Access Compliance Report

Public Rights-of-Way

(Curb Ramps)

Intersection ID: N/A	Main Street: LITTLE ROCK RD	Cross Street: N/A	Location: N
ADA ID: BE0F563D0A85	Ramp Type: Para	Initial Pass/Fail: Pass	Overall Compliance: No
		Severity Score: 0

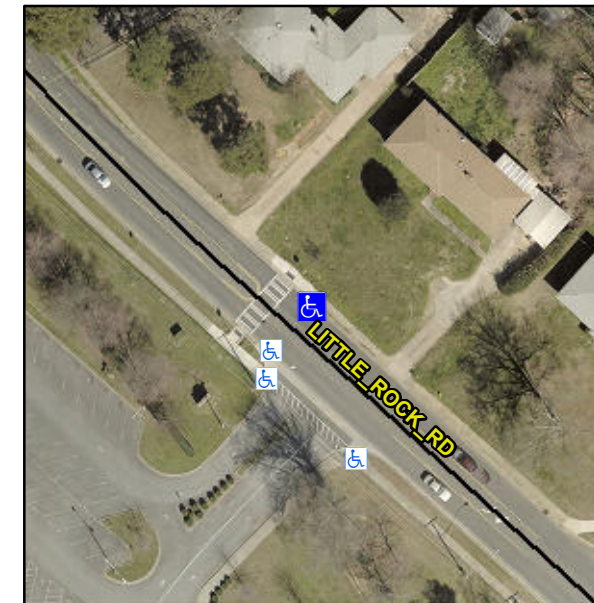
R304.2.1, R304.5.3, R305.2

Compliance	Description	Data	Compliance	Description	Data
N/A	Ramp Length LT (in)	54.0	N/A	Ramp Length RT (in)	61.0
Yes	Ramp Width LT (in)	59.0	Yes	Ramp Width RT (in)	57.0
Yes	Ramp Slope LT (%)	5.2	Yes	Ramp Slope RT (%)	6.0
Yes	Ramp XSlope LT (%)	0.9	Yes	Ramp XSlope RT (%)	1.0
No	Landing Length (in)	57.0	Yes	DWS Provided?	Yes
Yes	Landing Width (in)	60.0	Yes	DWS Contrast?	Yes
Yes	Landing Slope (%)	1.2	Yes	DWS Length (in)	24.0
No	Landing X Slope (%)	4.4	Yes	DWS Full Width?	Yes
N/A	Landing Curb? (Y/N)	Yes	No	DWS Offset (in)	2.5
N/A	Shared Landing?	No			
Yes	Gutter Ponding?	No	Yes	Gutter Slope (%)	0.1
Yes	Gutter Lip Ht (in)	0.0	Yes	Gutter X Slope (%)	2.7
N/A	Painted X Walk1?	Yes	N/A	Painted X Walk2?	N/A
	X Walk 1 Direction	To SW		X Walk 2 Direction	N/A
N/A	X Walk 1 Width (in)	114.0	N/A	X Walk 2 Width (in)	N/A
	X Walk 1 Slope (%)	1.7		X Walk 2 Slope (%)	N/A
	X Walk 1 X Slope (%)	3.0		X Walk 2 X Slope (%)	N/A
Yes	Ramp inside XWalk1?	Yes	N/A	Ramp inside XWalk2?	N/A

Remove & Replace Entire Ramp.
